**Consumers
Power
Company**

DOCKETS 50-155 & 50-255 - LICENSES DPR-6 & DPR-20 -
BIG ROCK POINT AND PALISADES PLANTS - PROPOSED
TECHNICAL SPECIFICATIONS CHANGE REQUEST -
SECTION 6 - ADMINISTRATIVE CONTROLS

CONSUMERS POWER COMPANY
Docket 50-155
Request for Change to the Technical Specifications
License DPR-6

CONSUMERS POWER COMPANY
Docket 50-255
Request for Change to the Technical Specifications
License DPR-20

Figure 6.2-1

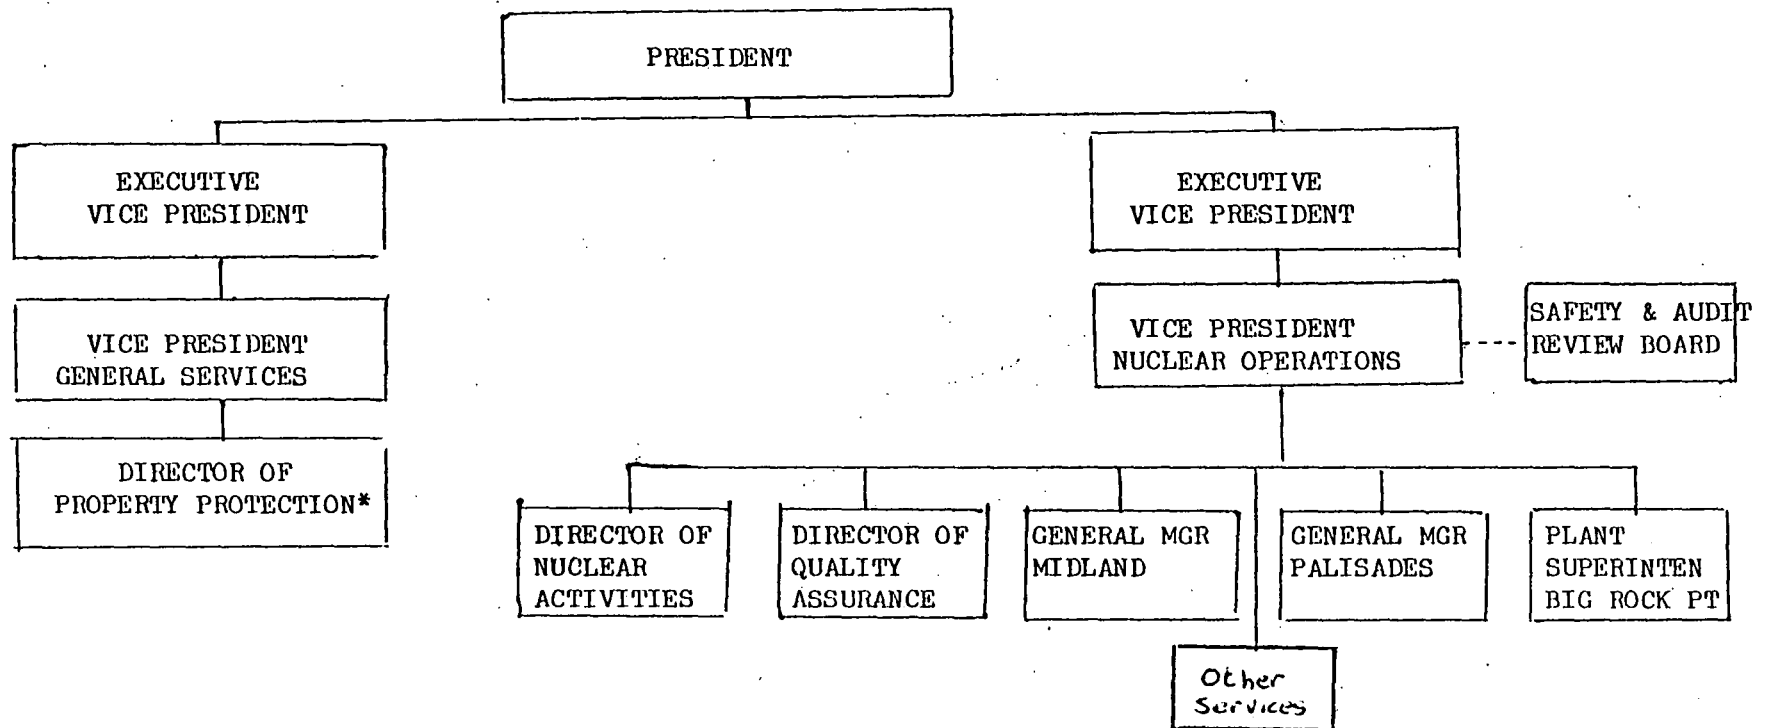
All proposed changes within the text of the Administrative Controls Section (Chapter 6) of the Technical Specifications are consistent with the changes on the organization charts (Figures 6.2-1 and 6.2-2).

- Figure 6.2-1
- Figure 6.2-2
- Section 6.5.1.2
- Section 6.5.1.6.e
- Section 6.5.1.7.c
- Section 6.5.1.8
- Section 6.5.2.1
- Section 6.5.2.3
- Section 6.5.2.4
- Section 6.5.2.9
- Section 6.5.2.10
- Section 6.5.2.11.a
- Section 6.5.2.11.b
- Section 6.5.2.11.c
- Section 6.6.1.b
- Section 6.7.1.b
- Section 6.7.1.d

Figure 6.2-1

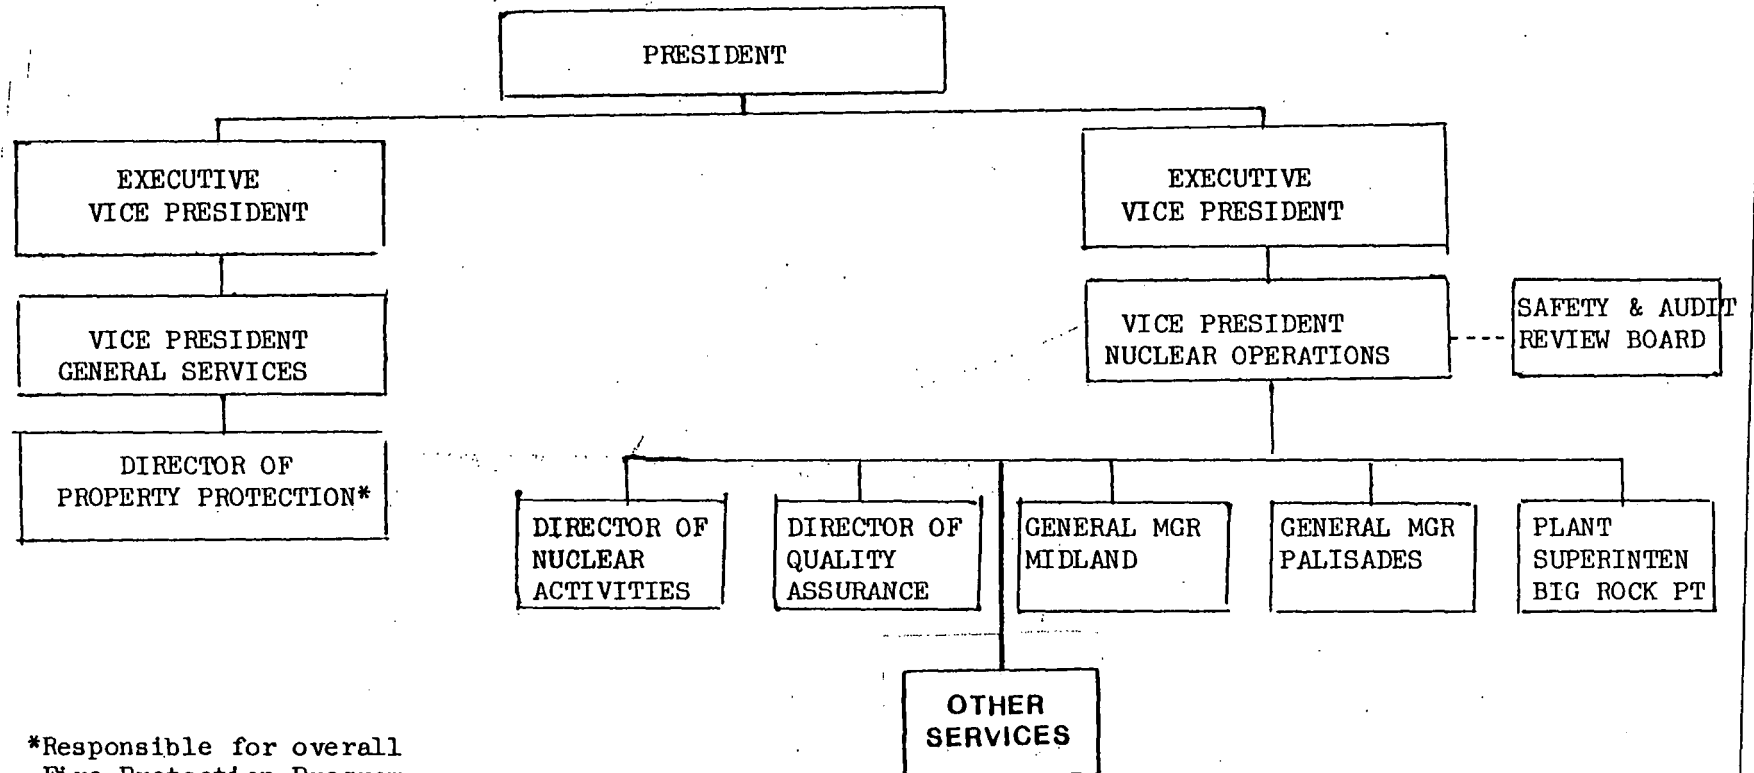
All proposed changes within the text of the Administrative Controls Section (Chapter 6) of the Technical Specifications are consistent with the changes on the organization charts (Figures 6.2-1 and 6.2-2).

- Figure 6.2-1
- Figure 6.2-2
- Section 6.1.1
- Section 6.4.1
- Section 6.5.1.1
- Section 6.5.1.2
- Section 6.5.1.6.a
- Section 6.5.1.6.e
- Section 6.5.1.7.a
- Section 6.5.1.7.c
- Section 6.5.2
- Section 6.5.2.2
- Section 6.5.2.3
- Section 6.5.2.8
- Section 6.5.2.9
- Section 6.5.2.10.a
- Section 6.5.2.10.b
- Section 6.5.2.10.c
- Section 6.7.1.b
- Section 6.7.1.d
- Section 6.8.2
- Section 6.8.3.c

Figure 6.2-2

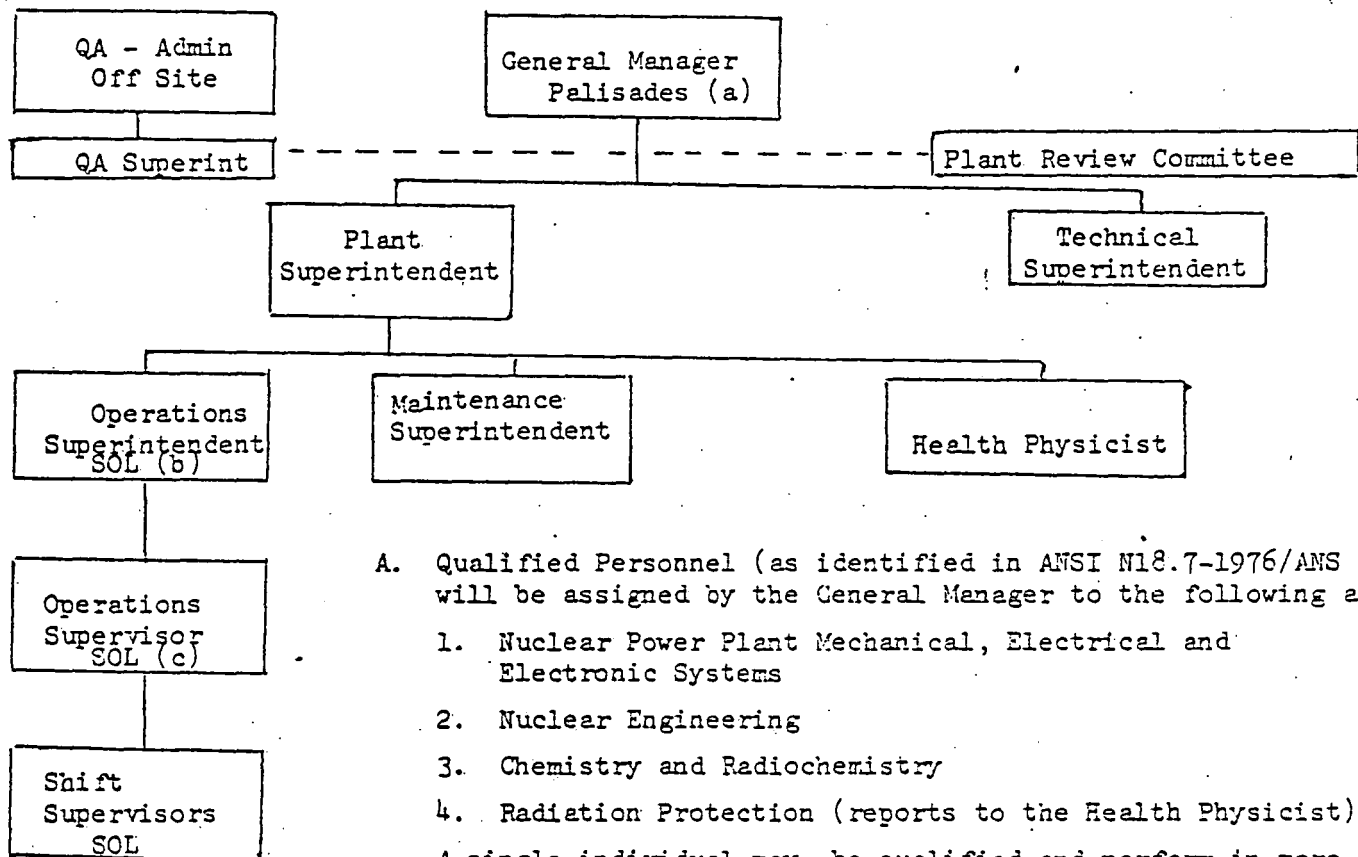
The proposed plant organization parallels that currently used at our Midland Plant. Under the proposed organization, a new position of General Manager is created and the responsibilities of the Plant Superintendent are modified. The General Manager is responsible for the safe, reliable and efficient operation of the Palisades Plant. The Plant Superintendent is responsible for coordinating the efforts of operations, maintenance and health physics functions of the plant. The personnel who have responsibility in these operational, maintenance and radiation protection areas report to the Plant Superintendent. This represents an enhancement of management attention to safety and radiation protection because the Plant Superintendent will not be responsible for the administrative functions to be handled by the General Manager or other personnel reporting to the General
